September 29, 2003

SUBJECT: Duke Energy Corporation (Duke)
McGuire Nuclear Station Units 1 and 2
Docket Nos. 50-369 / 50-370
Proposed Technical Specification (TS) Amendments
TS 3.7.15 - Spent Fuel Assembly Storage, and TS 4.3 -
Fuel Storage

Attachment 1 provides marked up pages of the existing McGuire TSs showing the proposed changes. Attachment 2 contains the new McGuire TS pages. The Description of Proposed Changes and Technical Justification is provided in Attachment 3. Pursuant to 10 CFR 50.92, Attachment 4 documents the determination that this proposed amendment contains no significant hazards considerations. Pursuant to 10 CFR 51.22 (c)(9), Attachment 5 provides the basis for the categorical exclusion from performing an Environmental Assessment or Impact Statement. A summary of the McGuire Spent Fuel Pool Criticality Analysis is shown in Attachment 6. Attachments 7 and 8 show the proposed and revised BASES for TS 3.7.14 and 3.7.15.

Figure 3.7.15-1 (page 1 of 1)
Required 3 out of 4 Loading Pattern for Restricted Region 1A Storage

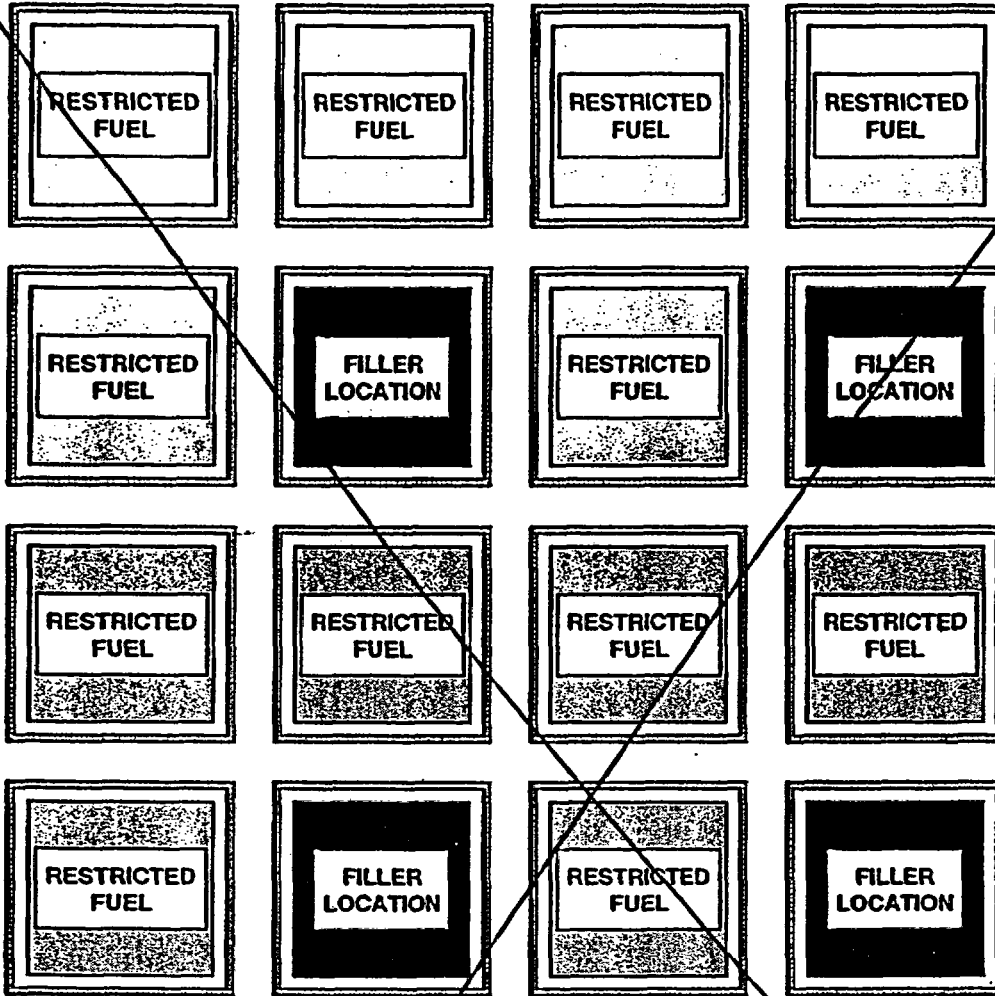
Delete all existing Figures 3.7.15-1 through 3.7.15-7 and replace with new Figures 3.7.15-1 through 3.7.15-2 (see Attachment 2)

Delete this Figure

Figure 3.7.15-2 (page 1 of 1)
Required 2 out of 4 Loading Pattern for Restricted Region 1B Storage

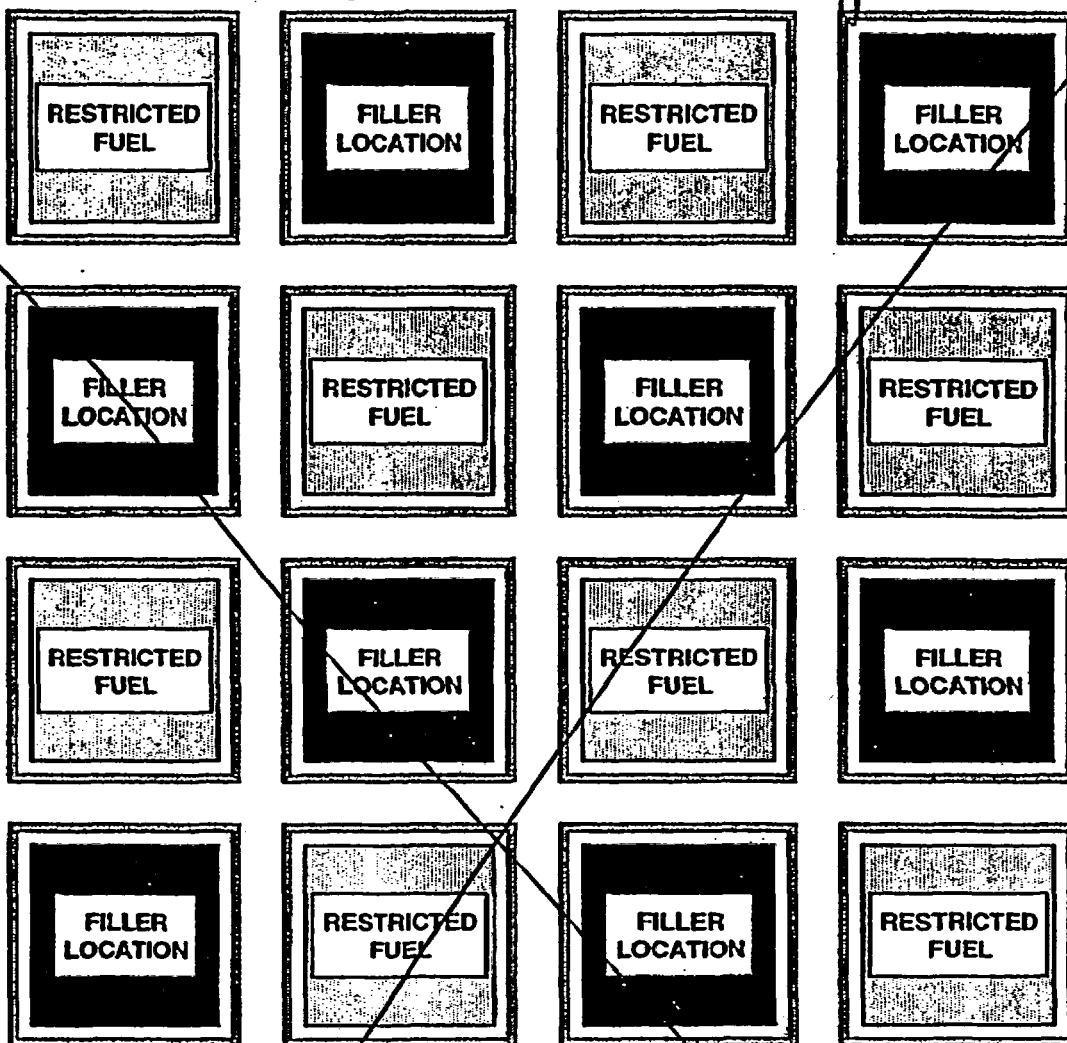
~~Set~~ Delete This Figure

Figure 3.7.15-3 (page 1 of 1)
Required 2 out of 4 Loading Pattern for Checkerboard Region 1B Storage

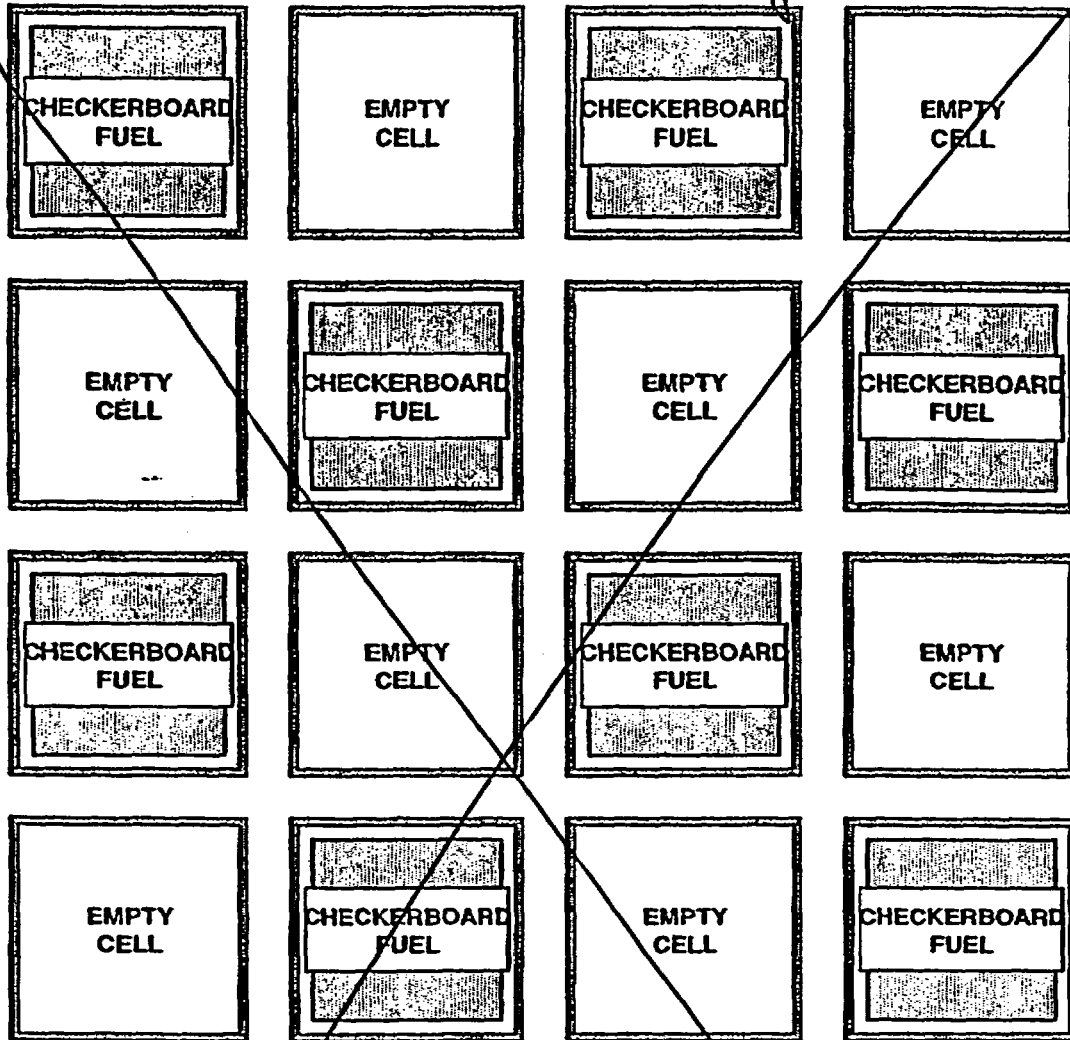
Delete this Figure

Figure 3.7.15-4 (page 1 of 1)
Required 2 out of 4 Loading Pattern for Restricted Region 2A Storage

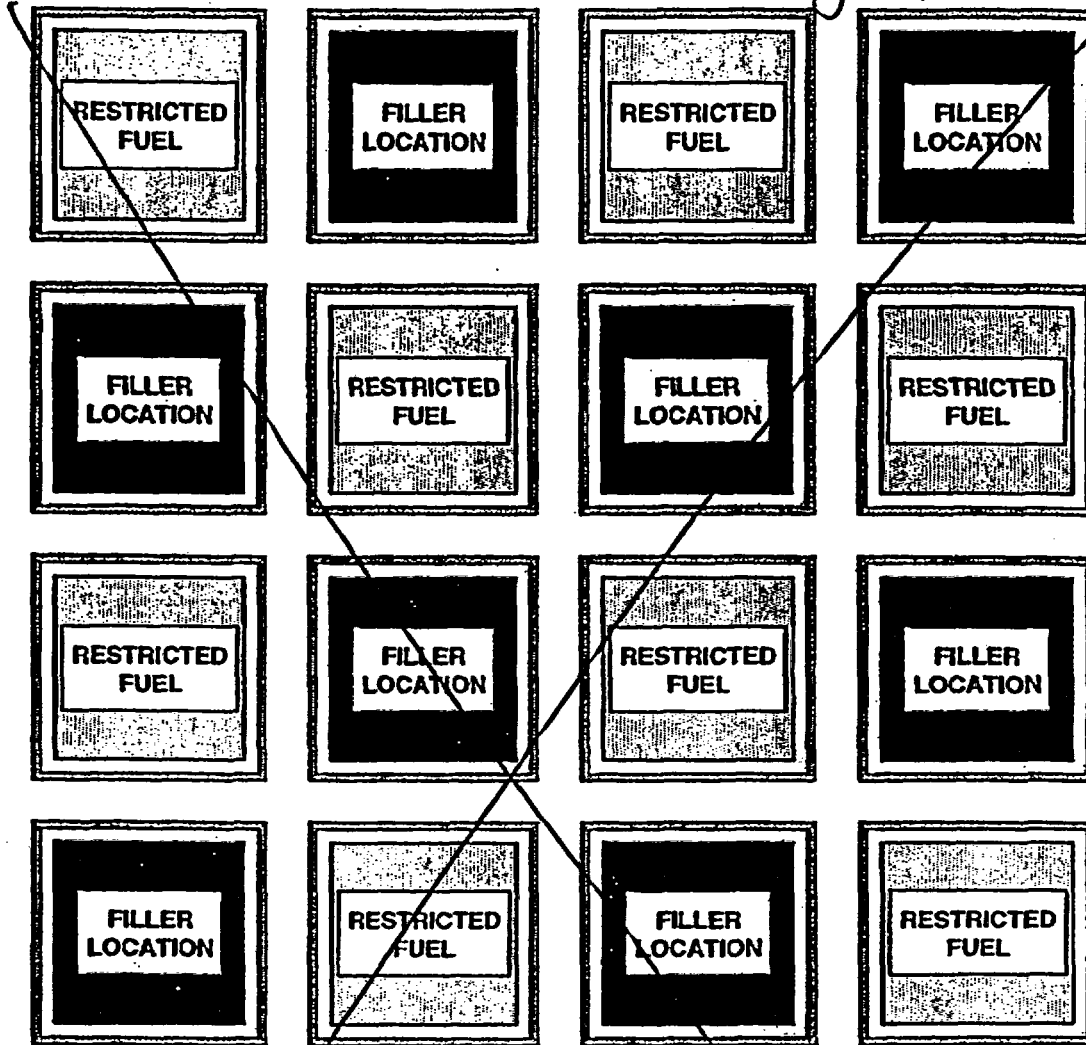
Delete Mis Figure

Figure 3.7.15-5 (page 1 of 1)
Required 2 out of 4 Loading Pattern for Checkerboard Region 2A Storage

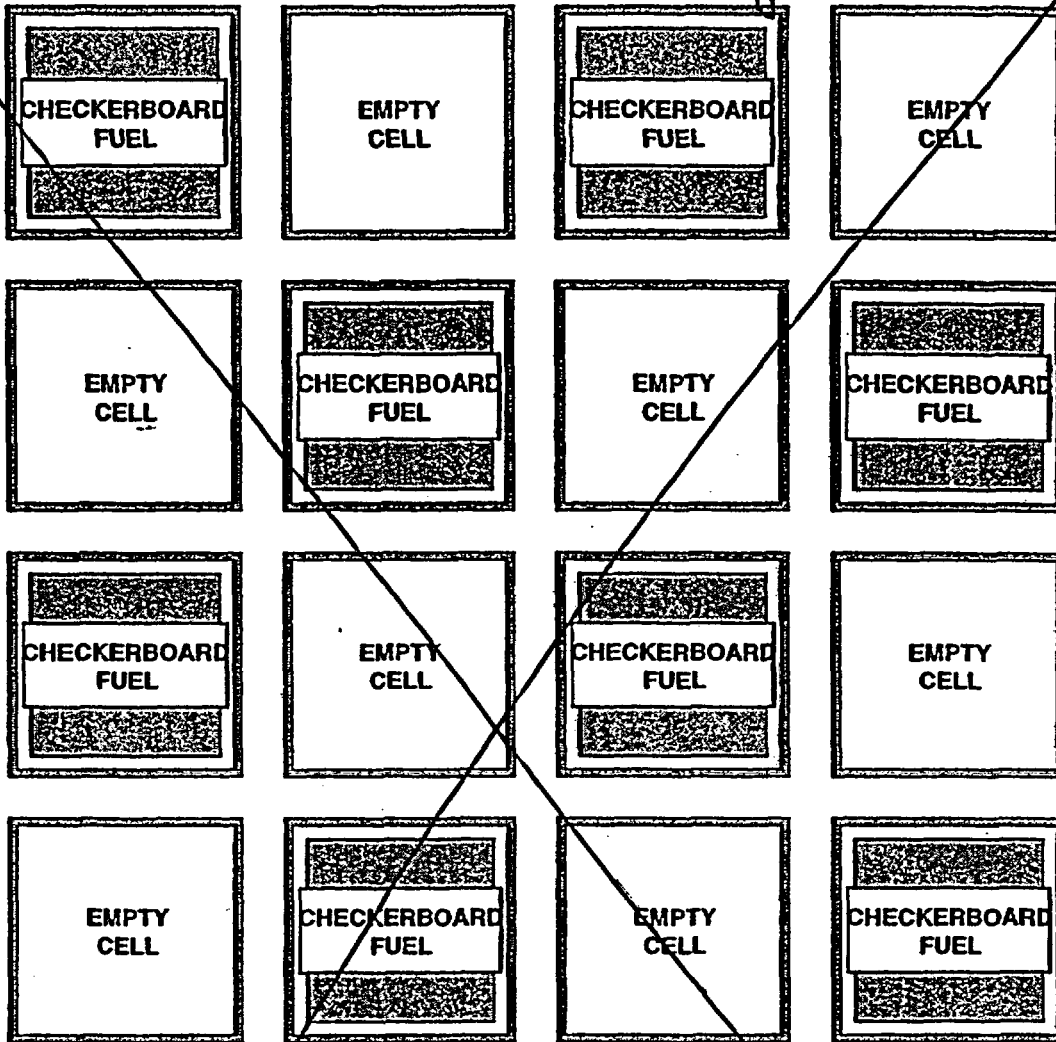
Delete this Figure

Figure 3.7.15-6 (page 1 of 1)
Required 1 out of 4 Loading Pattern for Restricted Region 2B Storage

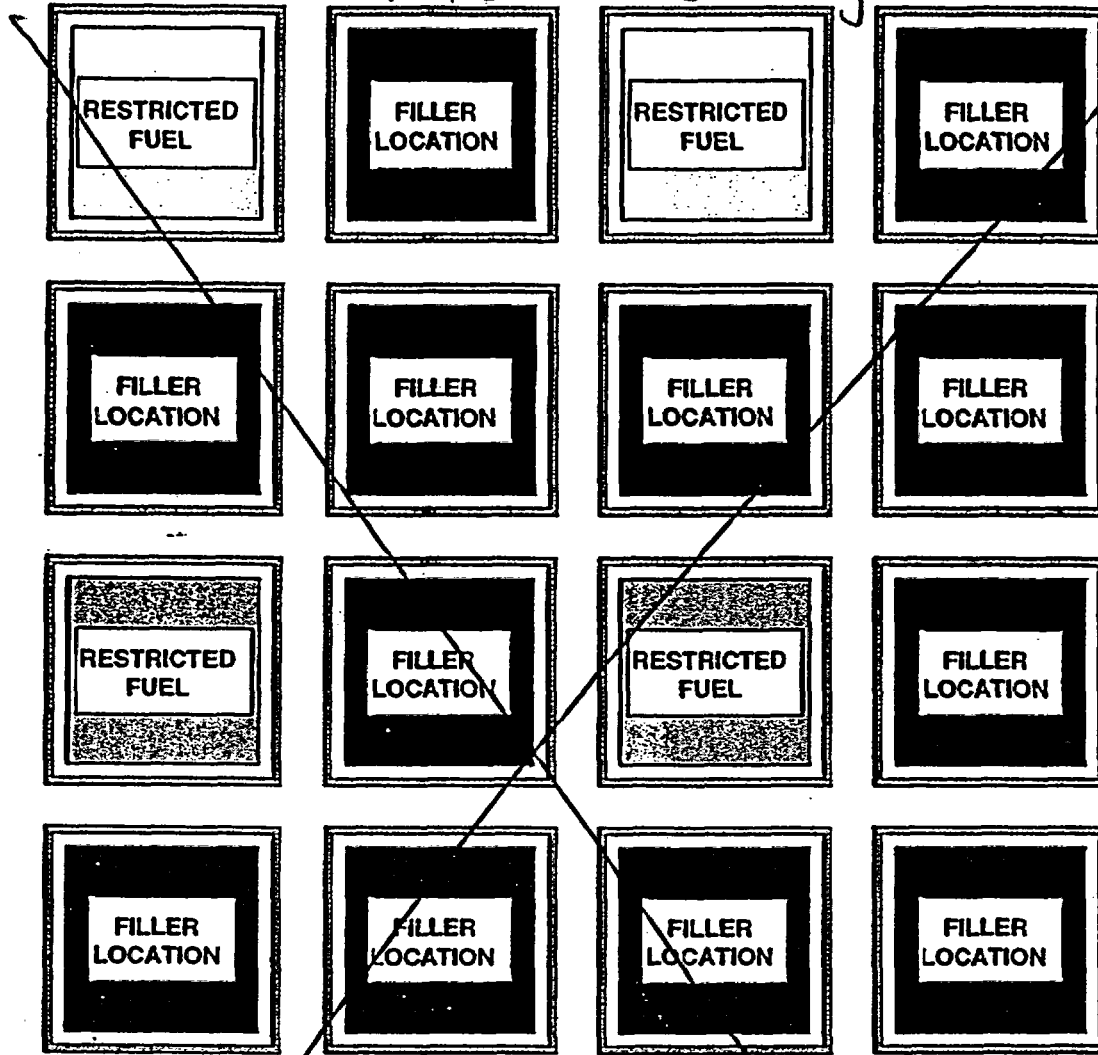
Delete This Figure

Figure 3.7.15-7 (page 1 of 1)
Required 1 out of 4 Loading Pattern for Checkerboard Region 2B Storage

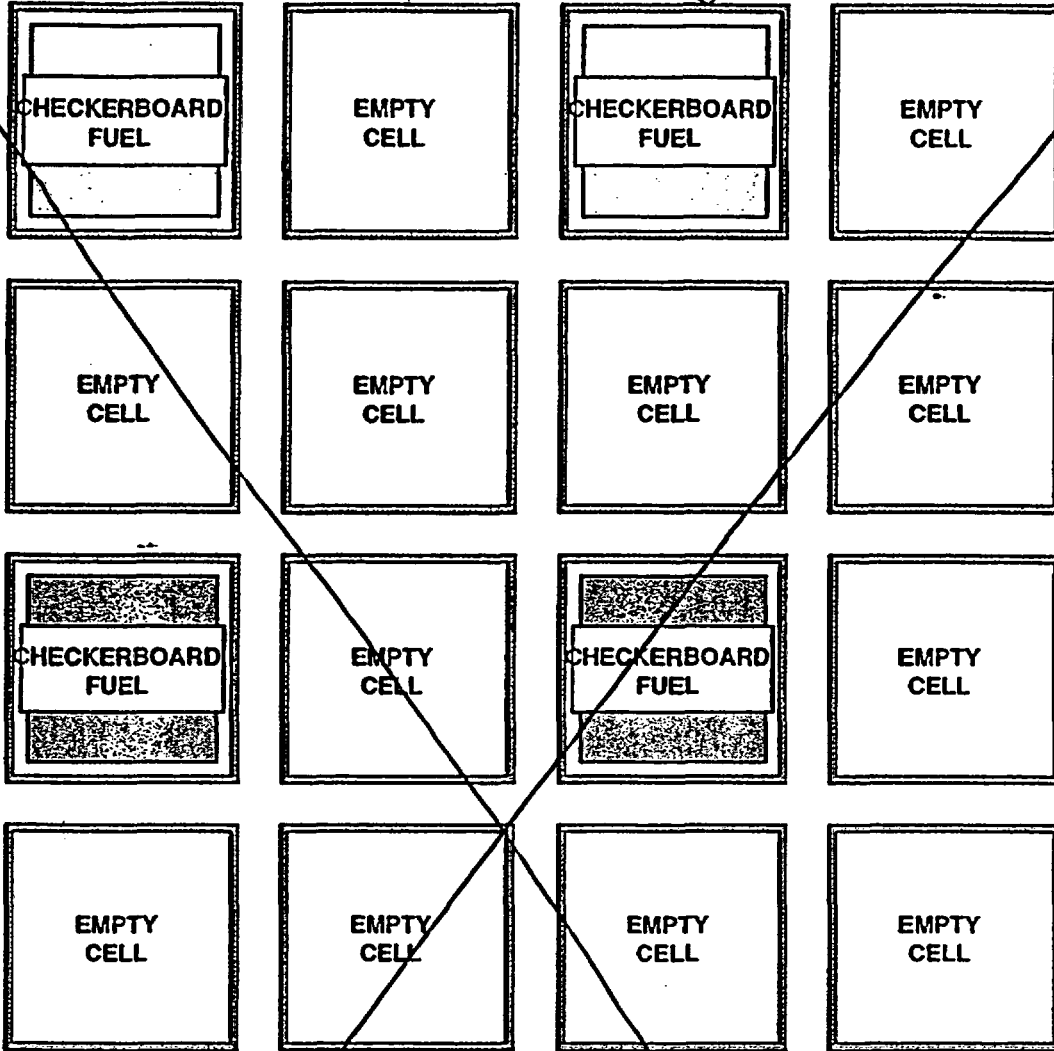
Delete This Figure

Figure 3.7.15-1 (page 1 of 1)
Required 2 out of 4 Loading Pattern for Restricted Region 2 Storage

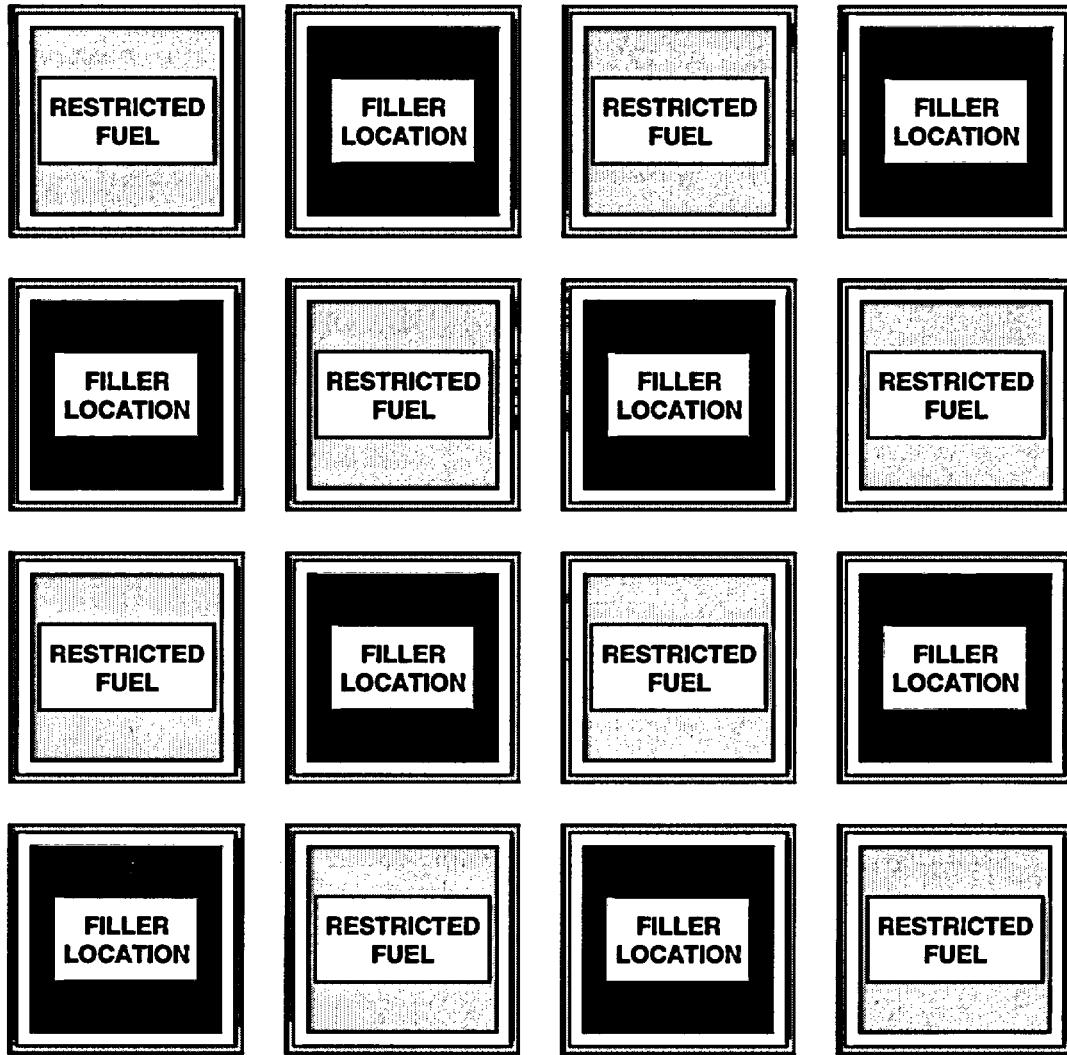
- l) New Figure 3.7.15-1:** This TS Figure illustrates the loading pattern to be employed in the Region 2 spent fuel storage racks for the 2 out of 4 restricted/filler storage configuration. There are no boundary conditions specified for this storage configuration. The loading pattern illustrated by this figure is based on the criticality analysis discussed in Attachment 6. The analysis no longer takes credit for any remaining Boraflex in the Region 2 spent fuel storage racks. For each fuel assembly design type, credit is taken for burnup, cooling time and partial credit for the soluble boron in the spent fuel pool water.

Figure 3.7.15-2 (page 1 of 1)
Required 3 out of 4 Loading Pattern for Checkerboard Region 2 Storage

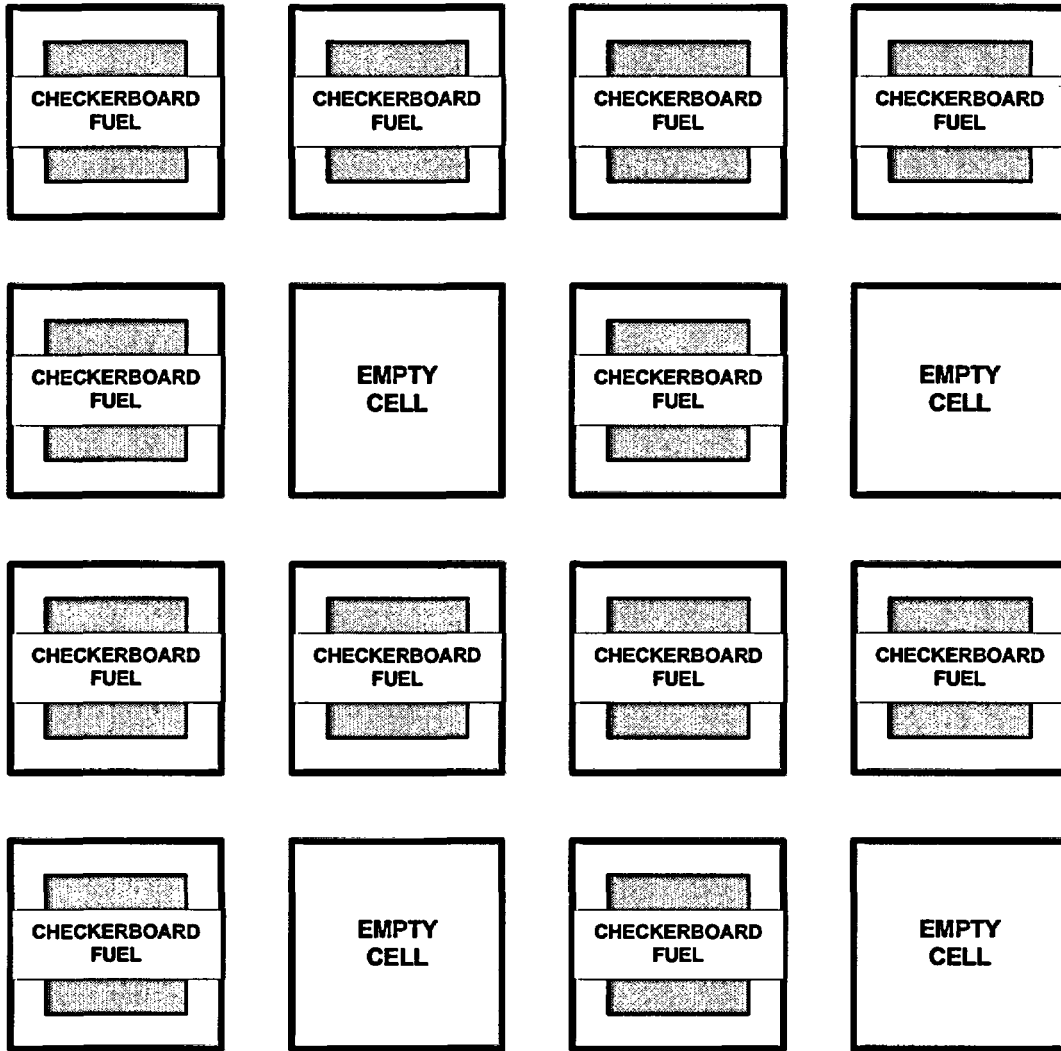
- m) New Figure 3.7.15-2:** This TS Figure illustrates the loading pattern to be employed in the Region 2 spent fuel storage racks for the 3 out of 4 checkerboard/empty cell storage configuration. Boundary conditions for this storage configuration are specified. For this configuration, a string of checkerboard fuel is to be bounded by either; 1) an alternating pattern of checkerboard fuel and empty cell, 2) string of empty cells, or 3) spent fuel pool wall. The loading pattern illustrated by this figure is based on the criticality analysis discussed in Attachment 6. The analysis no longer takes credit for any remaining Boraflex in the Region 2 spent fuel storage racks. For each fuel assembly design type, credit is taken for burnup, cooling time and partial credit for the soluble boron in the spent fuel pool water.
